BP#21-117 Deferred Maintenance Re-Roof at Lichen K-8 #159-9233-N1

ADDENDUM NO. 1

March 29, 2021

A122D
AD1.3

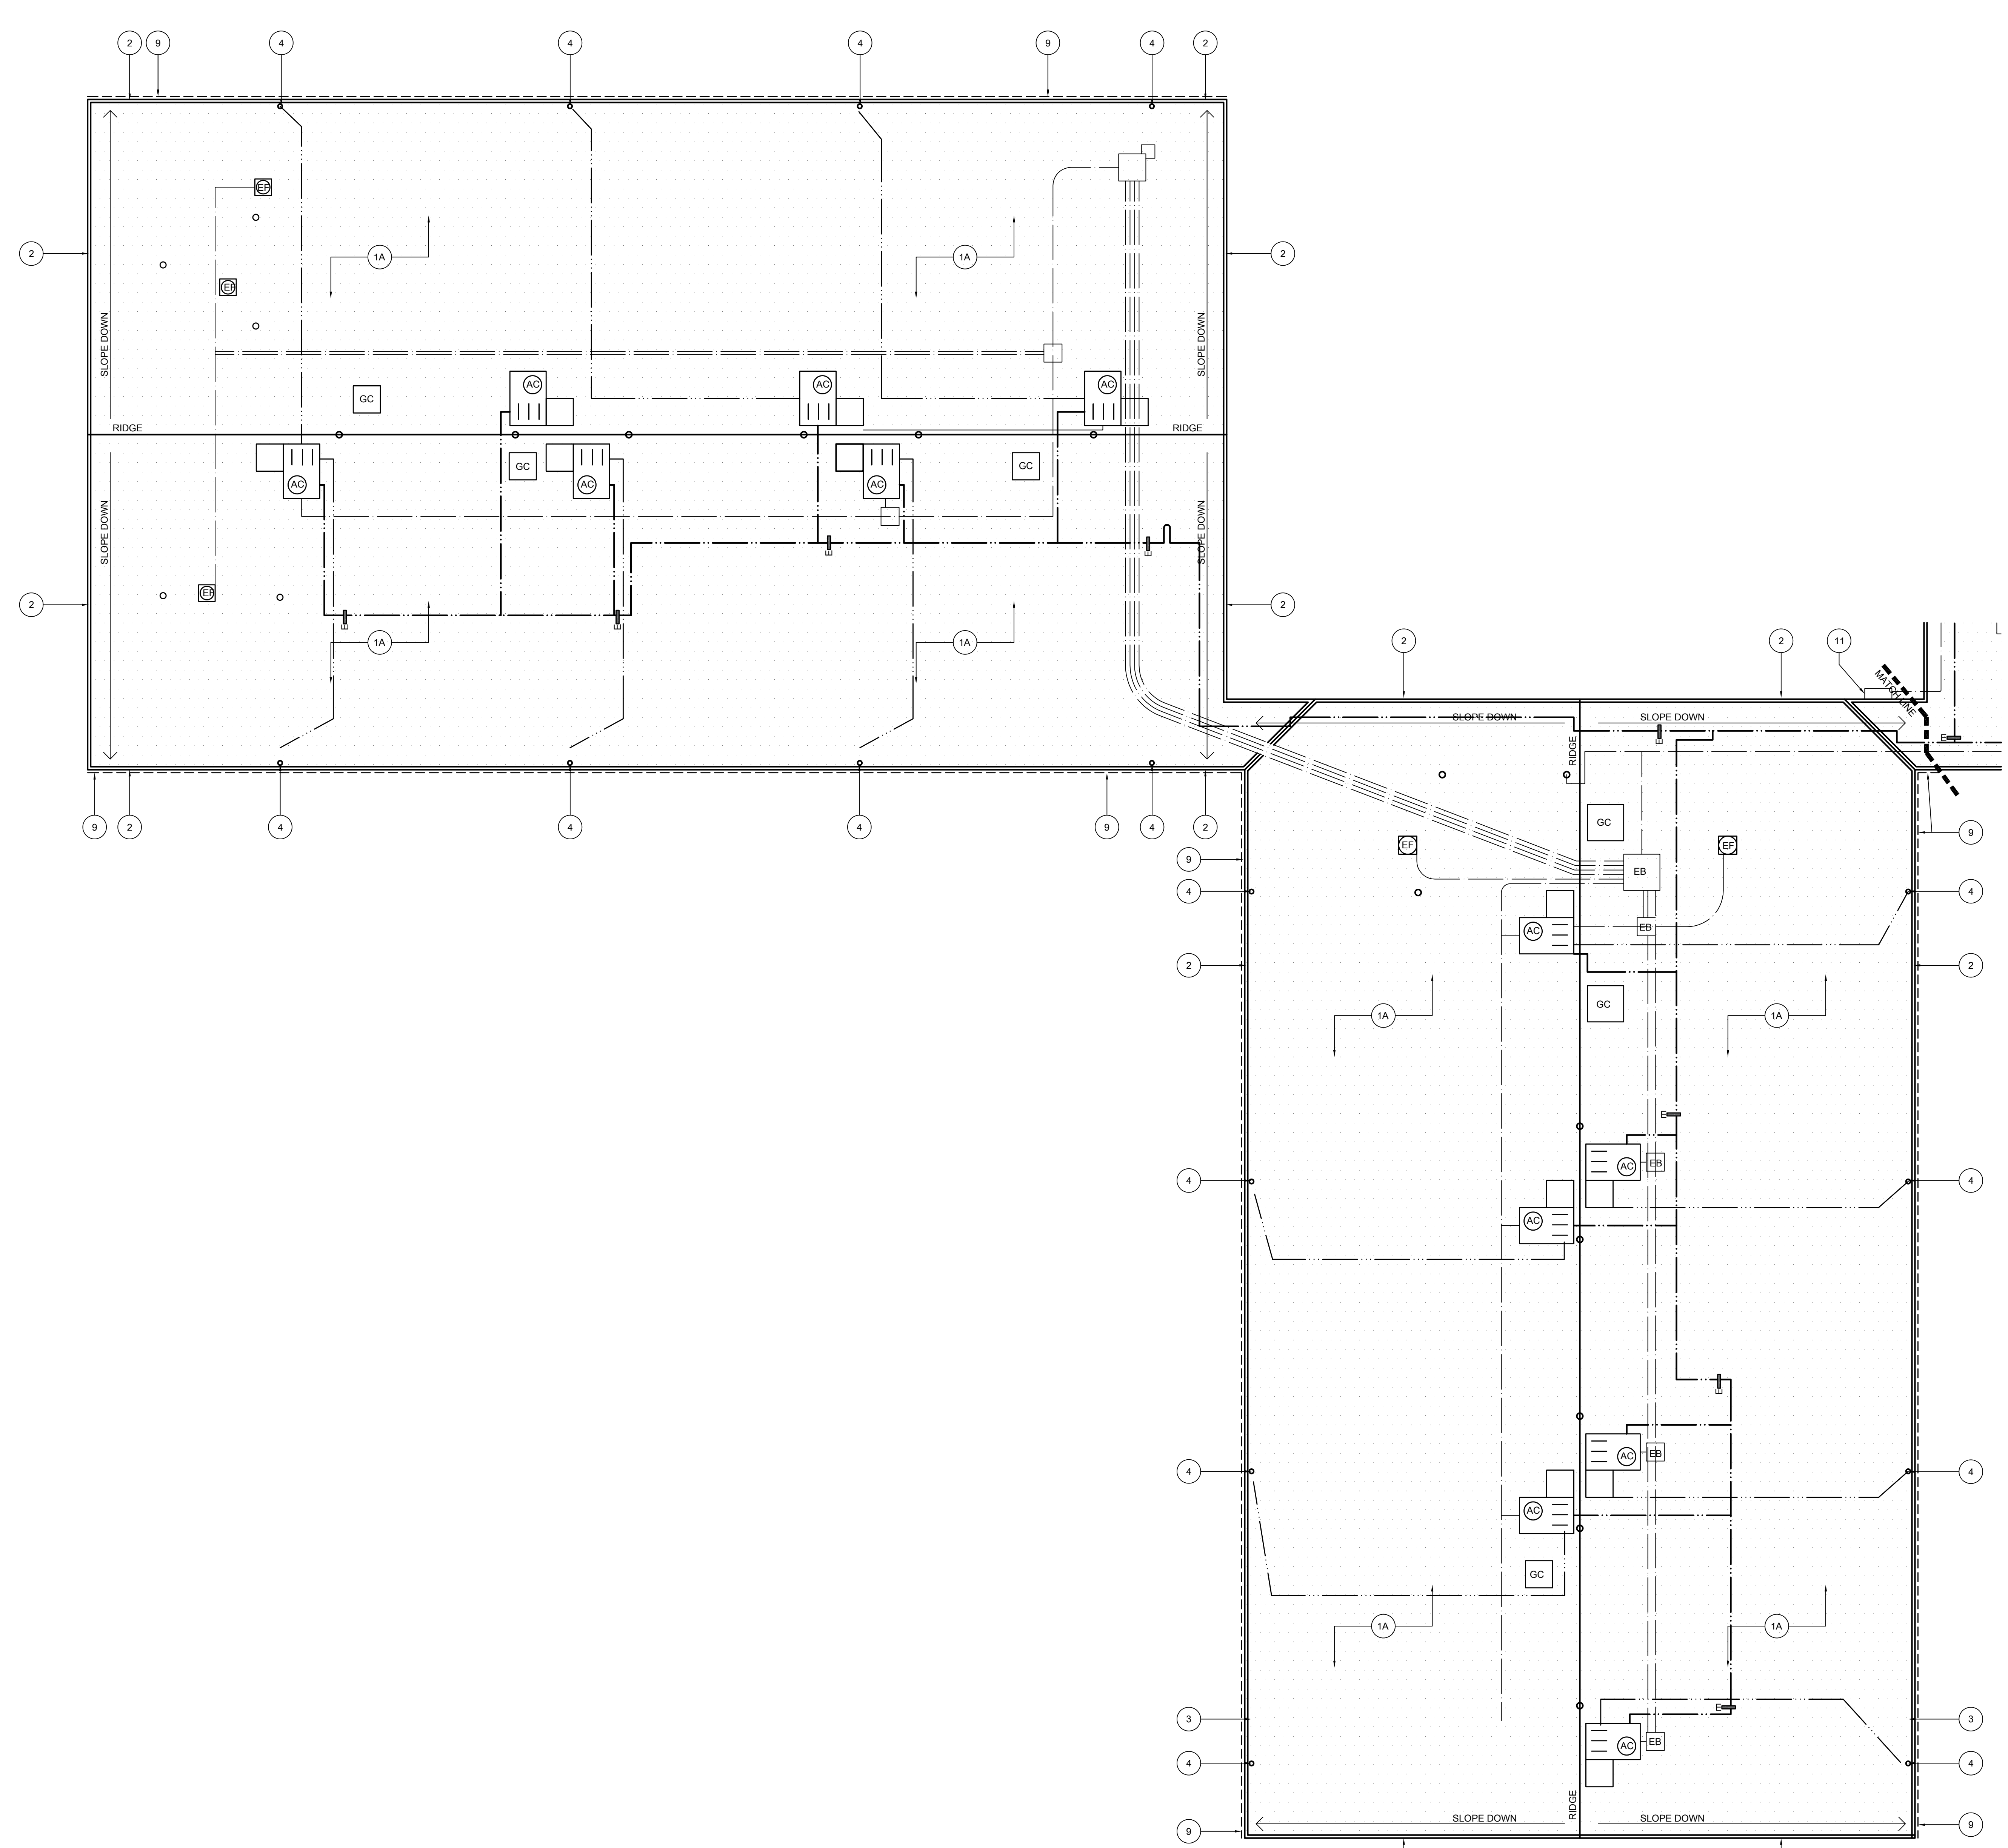
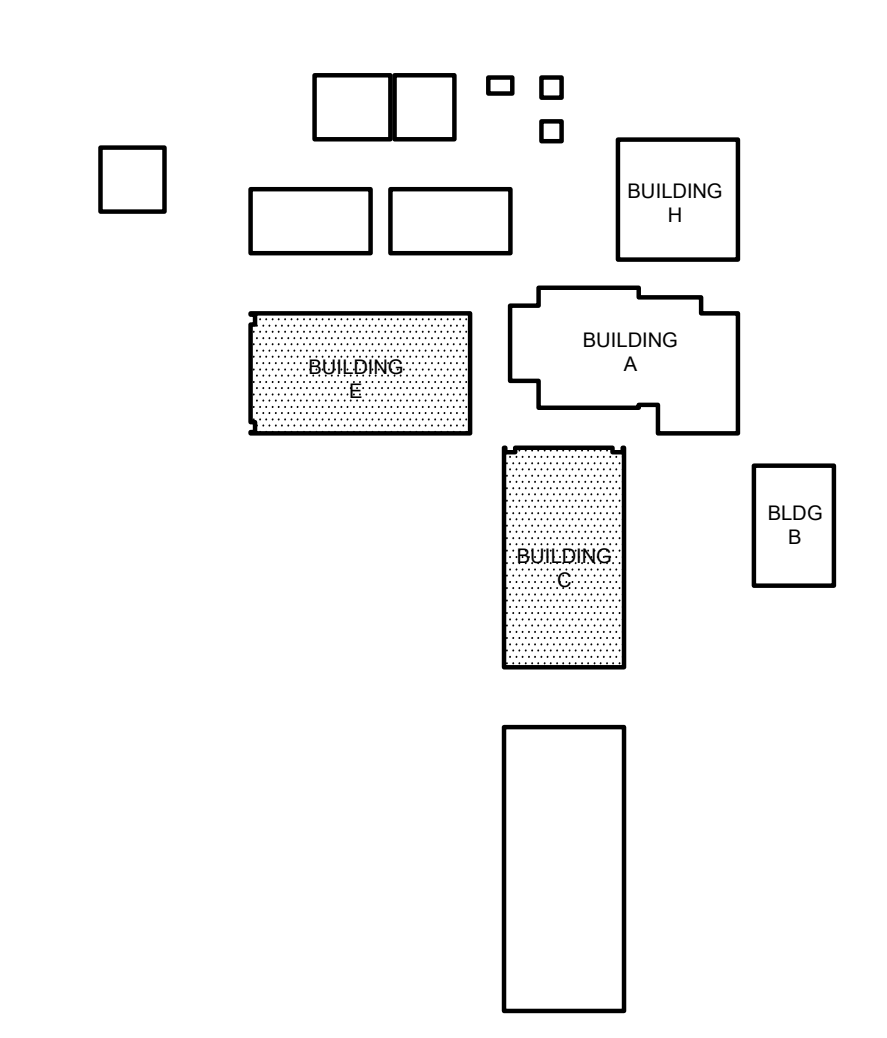
AD1.3 Sheet A122D - Replace in its entirety.

Keynote 3 corrected to Keynote 4 in several locations.
